*STP-209-1(2) Roadway and BHF-209-1(3) Bridge  
Widening of SR 74 From SR 85 to*

*P.I. Nos. 322355 and 322357*

**Value Engineering Study Report**

Preliminary Design Stage

Sht. 3 of 16  
ORIGINAL DESIGN

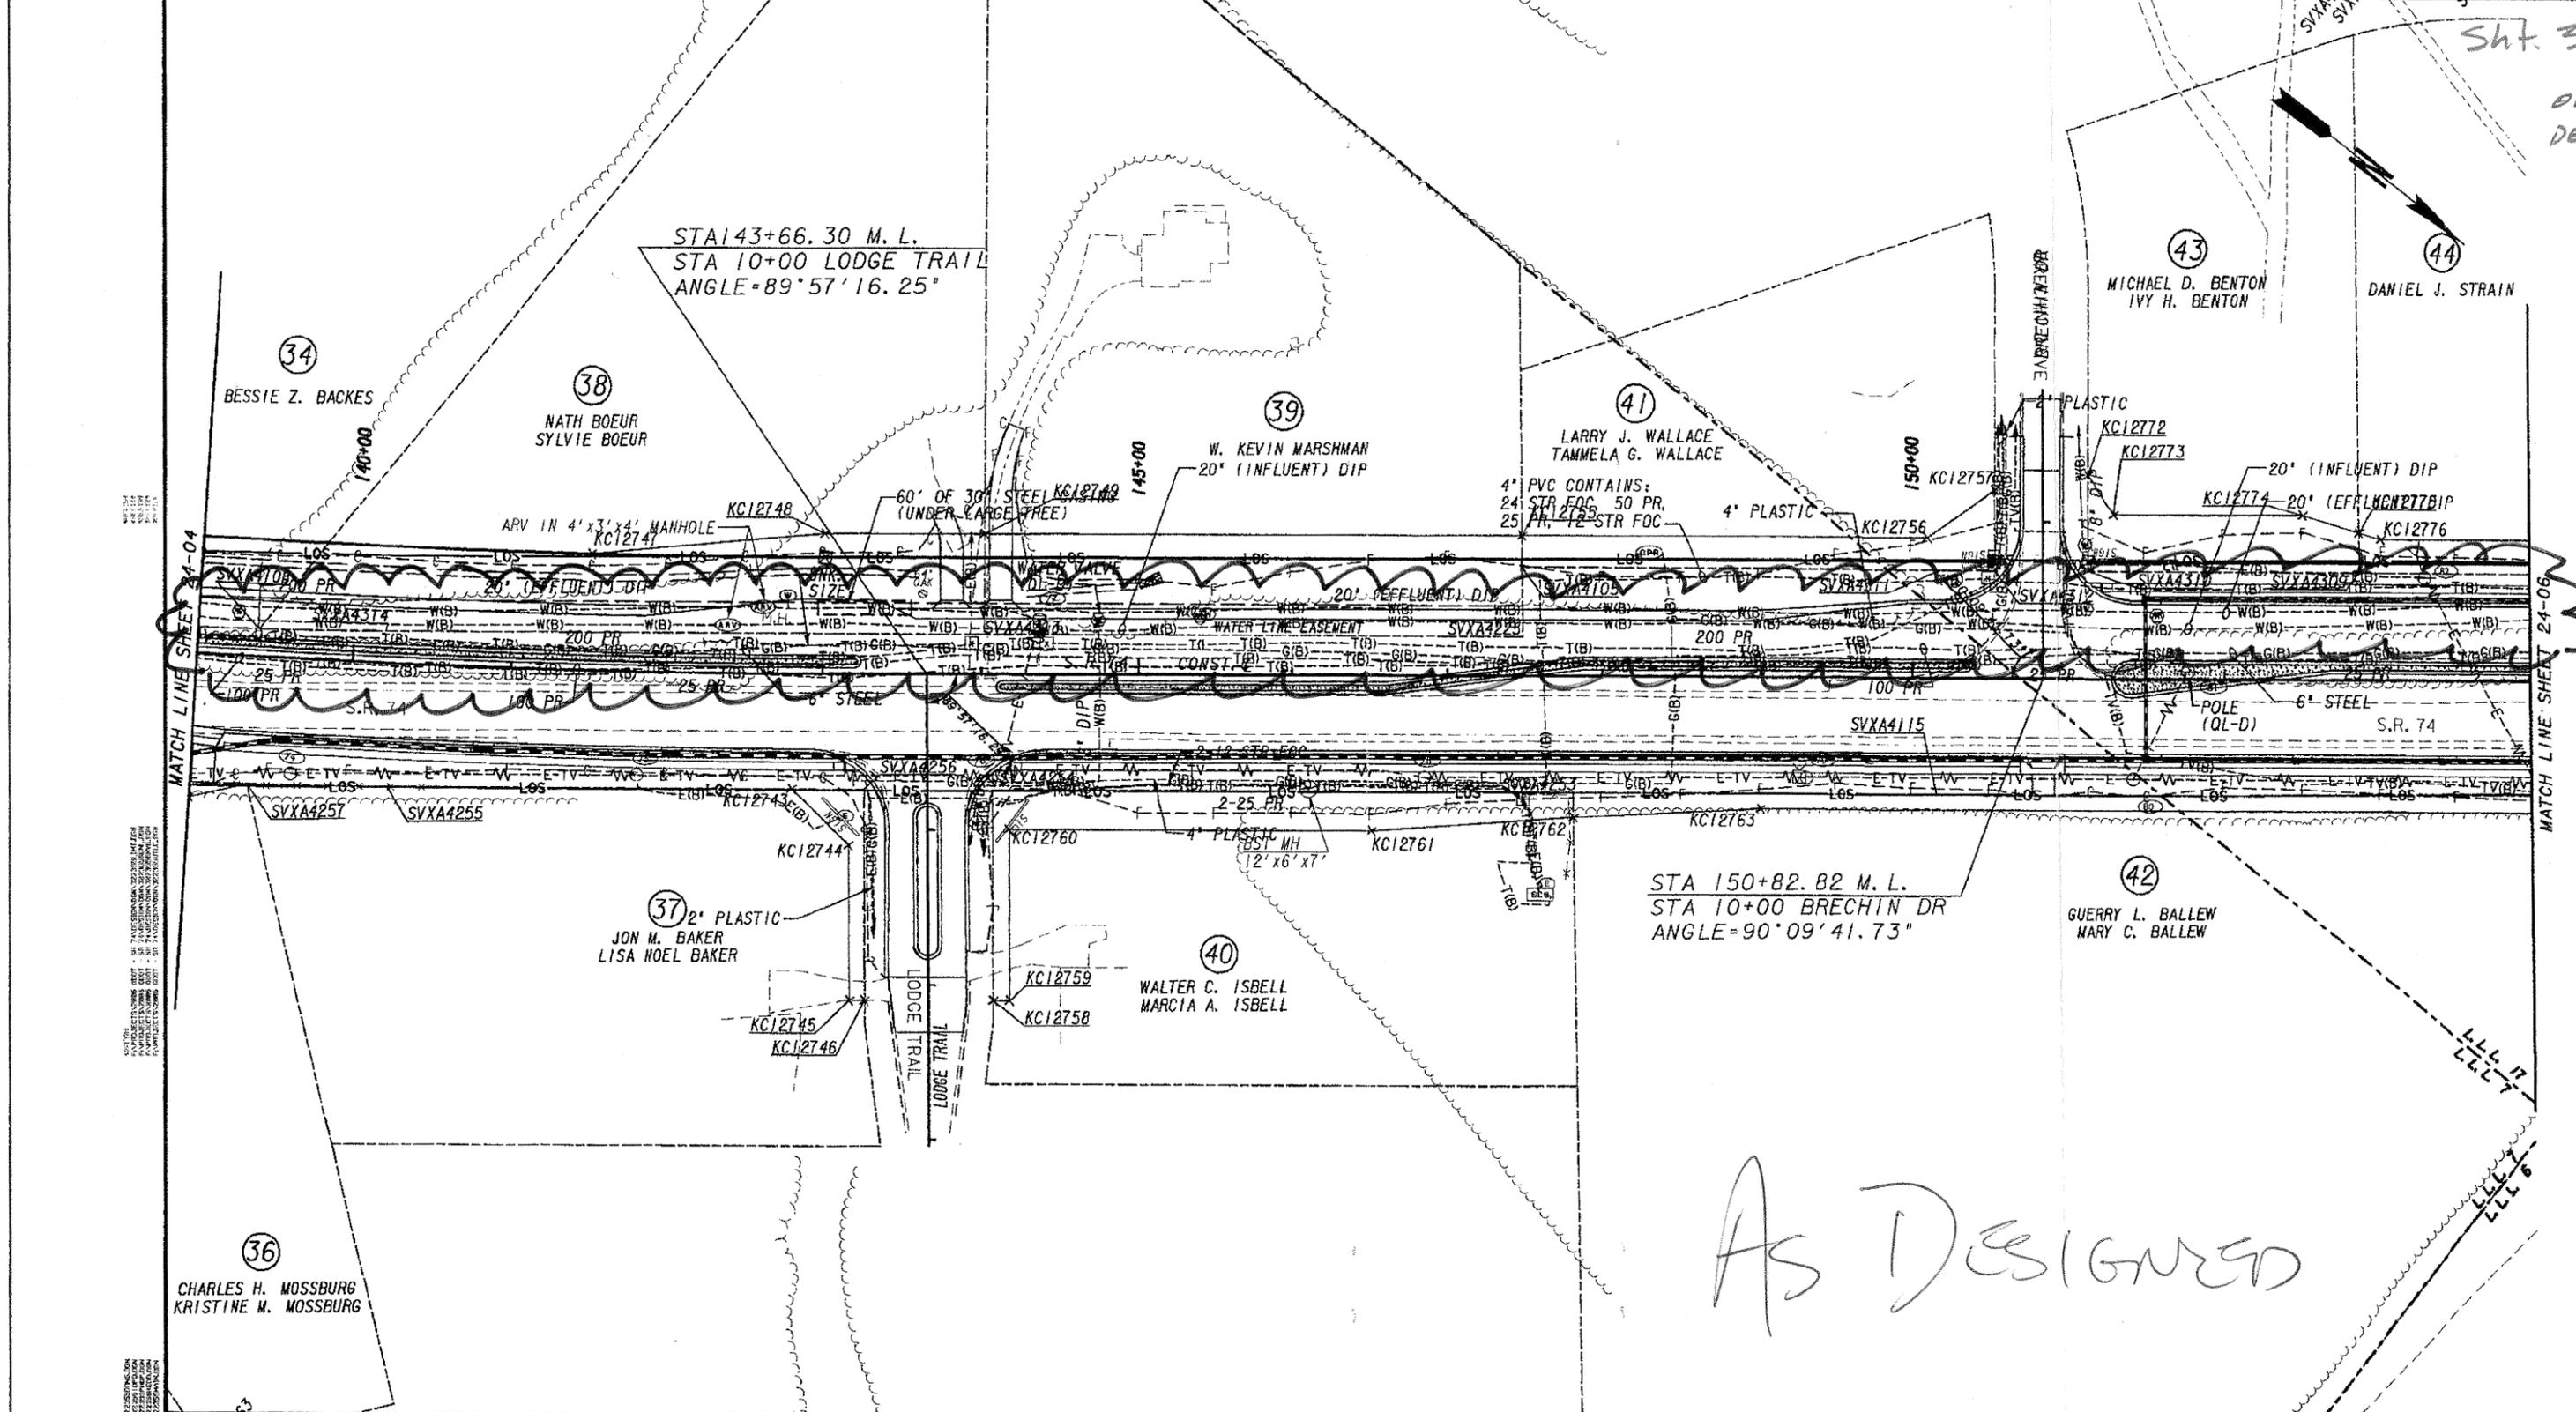
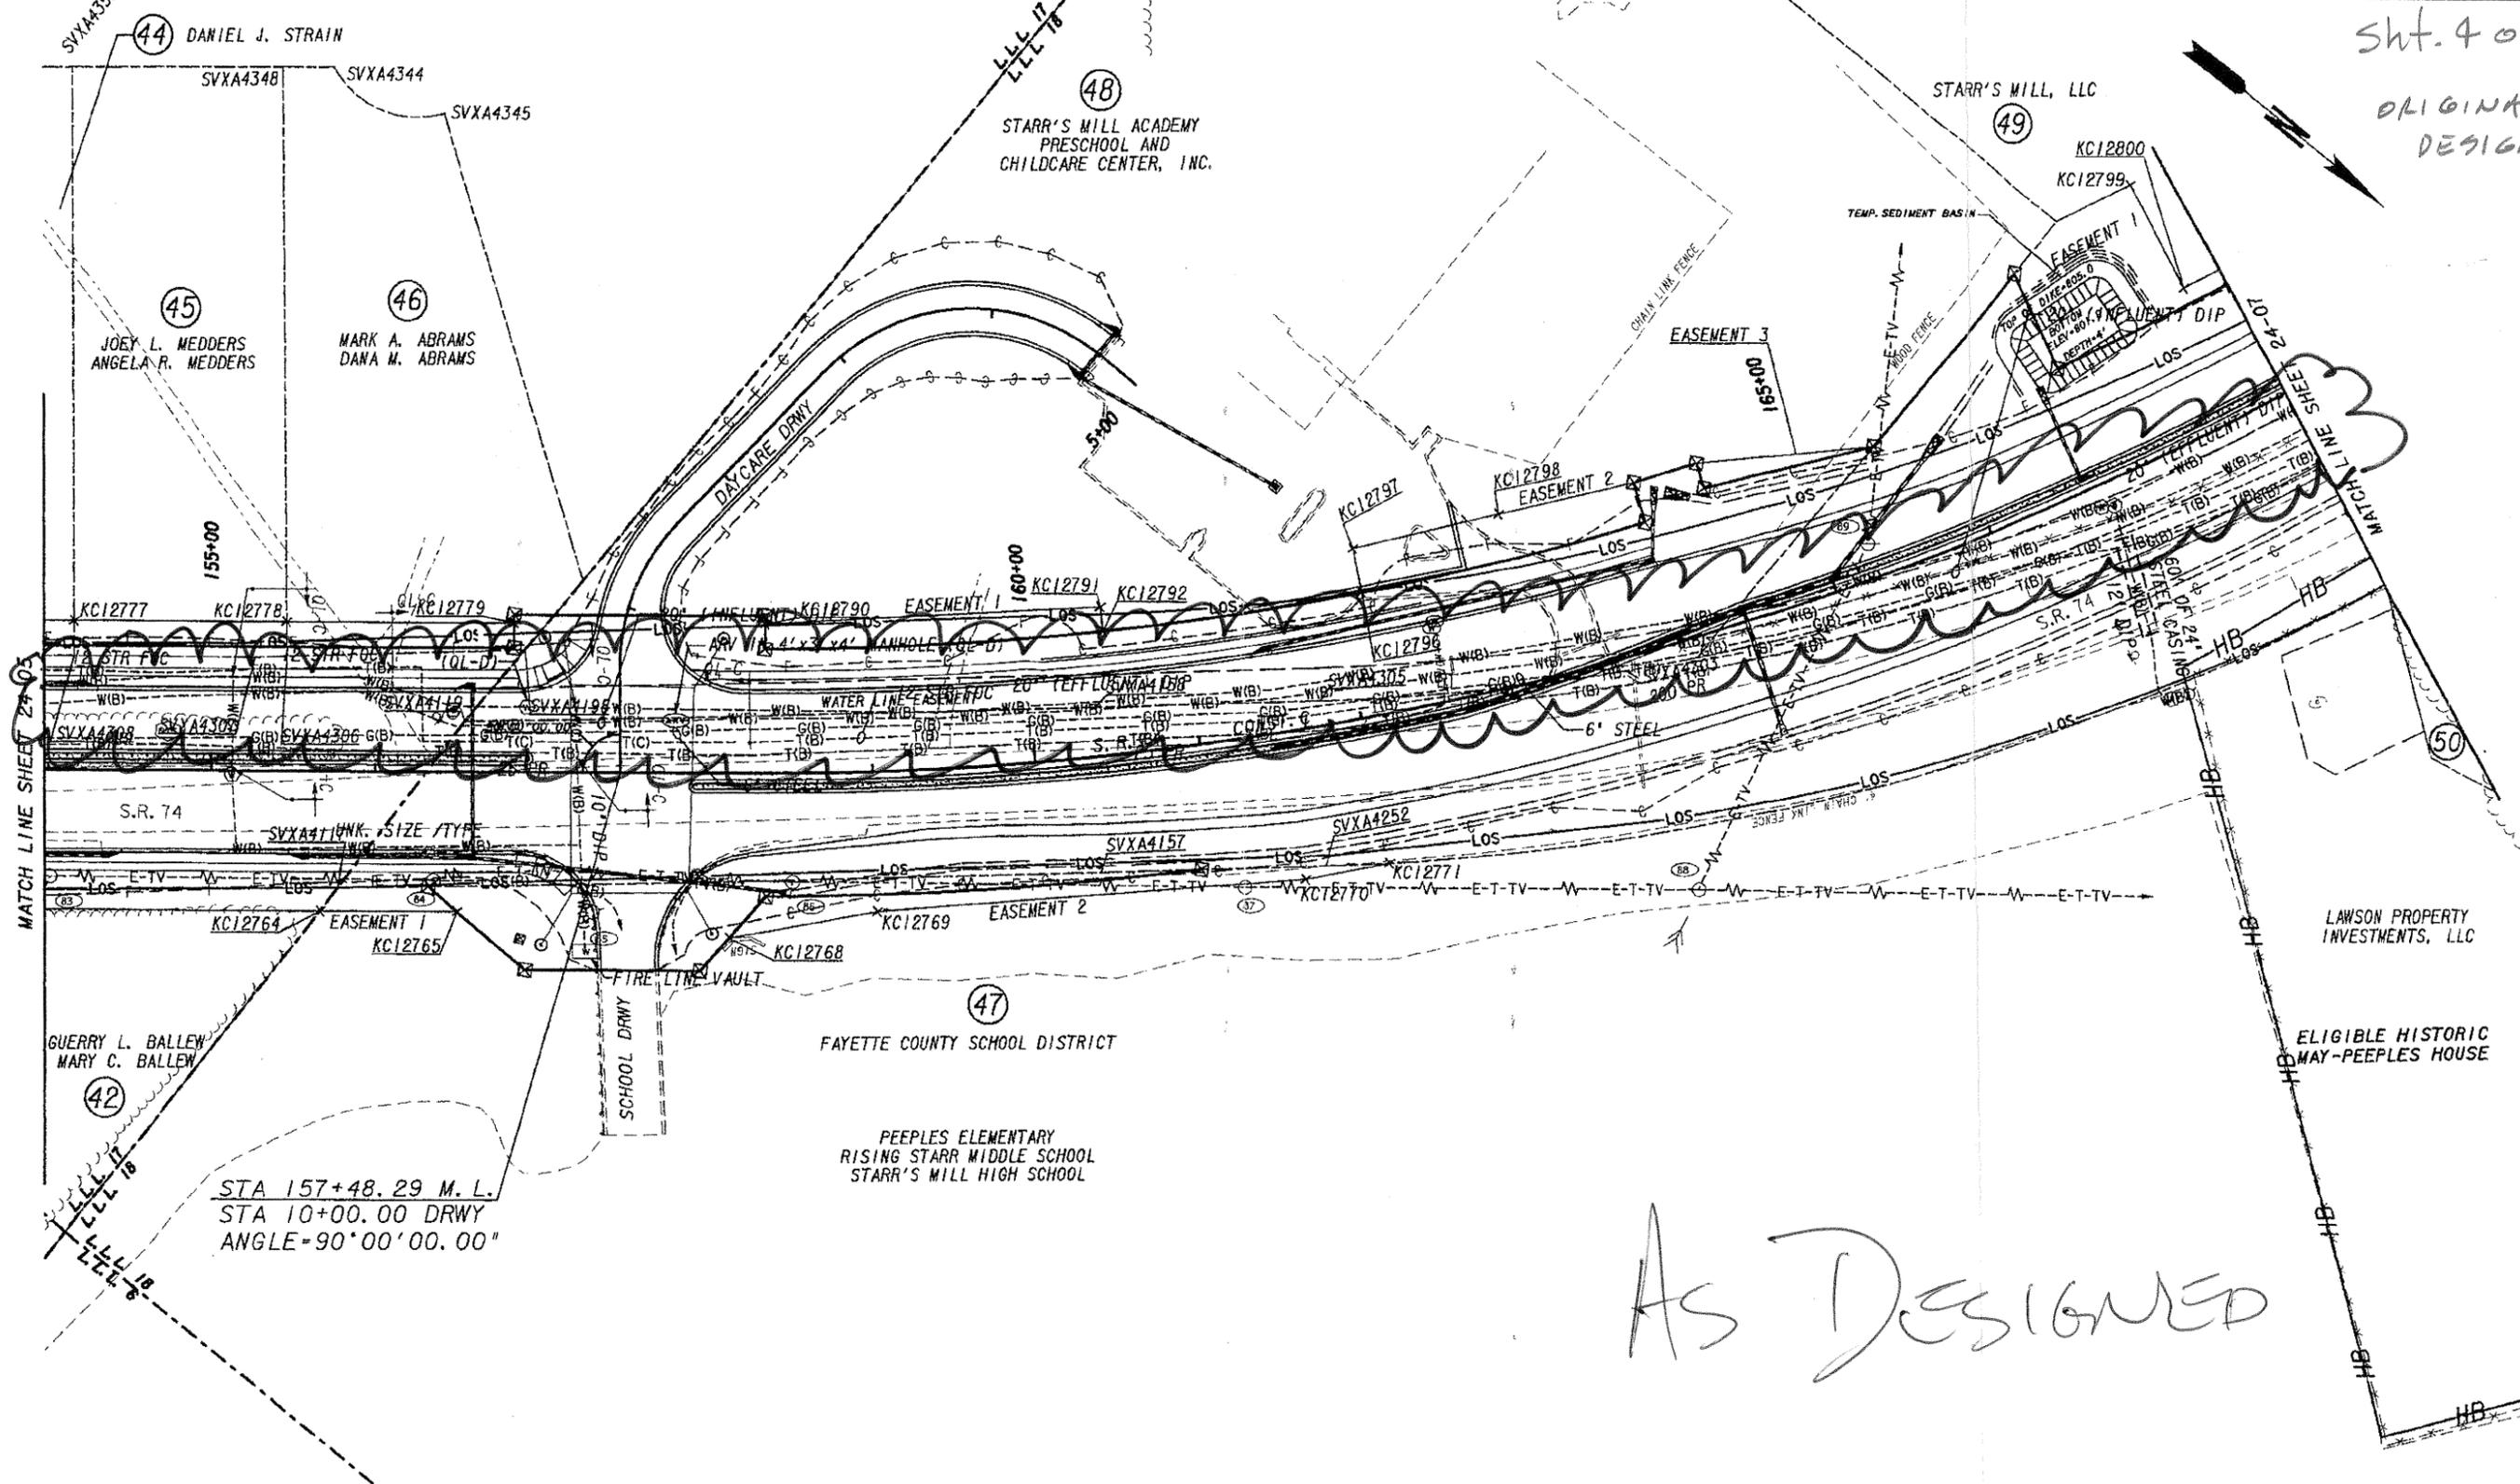
The current design assumes that the water lines are inexpensive and easy to relocate. The lines are trunk lines from the Peachtree City Water Treatment Plant. An effort has been made to avoid these lines outside of the station limits below.

With housing distances from the road often exceeding 100 ft., there does not appear to be a valid reason why the horizontal alignment can not be shifted to avoid the water lines. The right-of-way costs would not appreciably change, but amounts would be shifted from one side to the other.
